NUREG-2229

Safety Evaluation Report

Northwest Medical Isotopes, LLC
Construction Permit Application for
a Radioisotope Production Facility

Docket Number 50-609

Figure 13-1 Scaled Distance-Overpressure Relationship

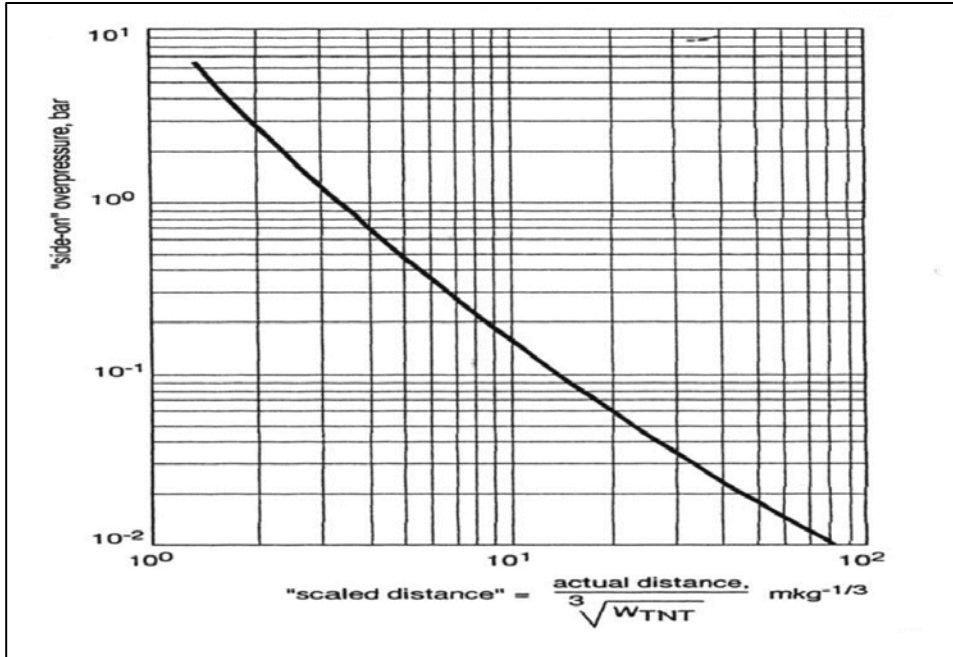
An evaluation of the potential damage from an ion exchange exothermic reaction was made using a correlation that related "scaled distance" for trinitrotoluene (TNT)-equivalent explosion to "side-on" overpressure that the nearest confinement barrier would experience. This correlation between scaled distance and overpressure is commonly found in the literature evaluating the effects of explosions.¹ SER Figure 13-1, "Scaled Distance-Overpressure Relationship," shows this distance-overpressure relationship. The use of this relationship is generally considered to be conservative because the energetic ion exchange reactions can often proceed at a slower, non-explosive rate resulting in reduced overpressures.
